**Burlington Historic Preservation Review Committee
Certified Local Government Program**

Memorandum to: Historic Preservation Review Committee
From: Mary O'Neil AICP, Coordinator, CLG Program
Date: July 10, 2018
RE: Requested de-listing of 36 Convent Square

To: The Design Advisory Board
From: Mary O'Neil, AICP, Principal Planner
RE: ZP18-1050CA, 16 Wilson Street
Date: June 26, 2018

BASEMENT FLOOR PLAN

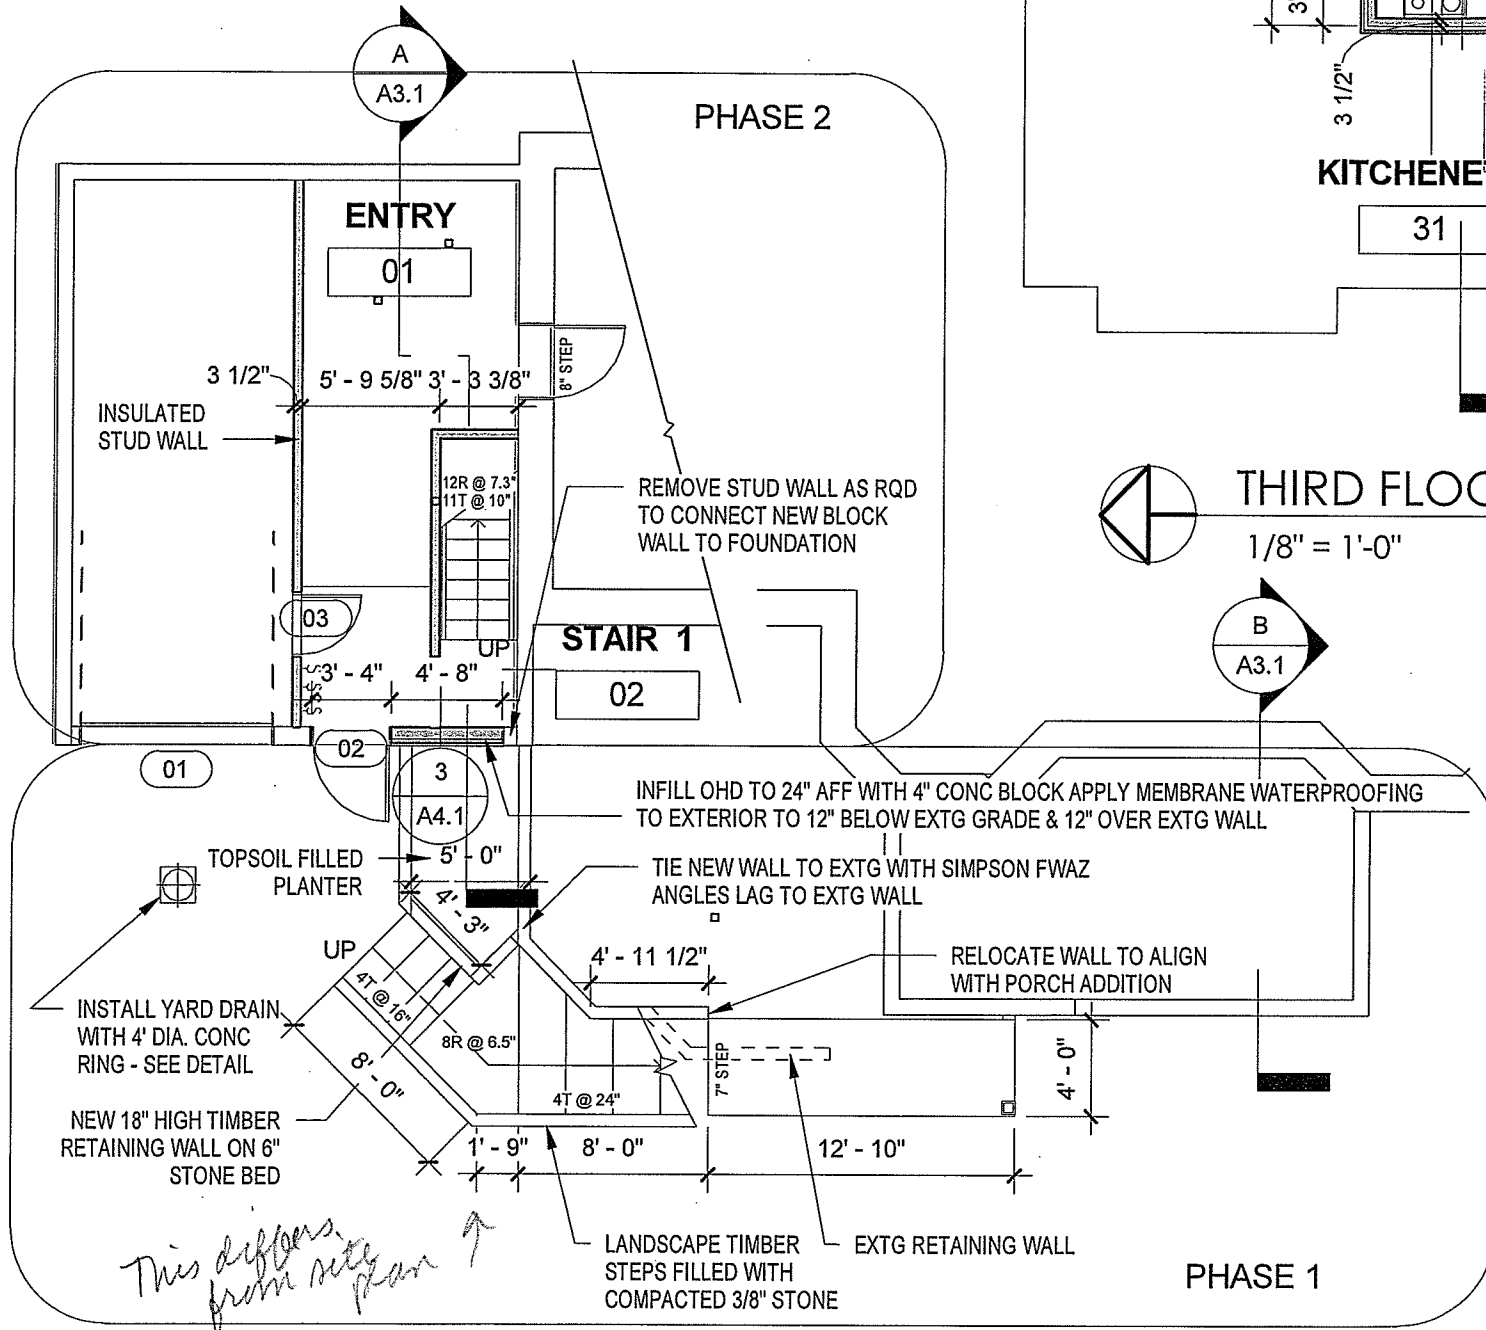
This differs from site plan
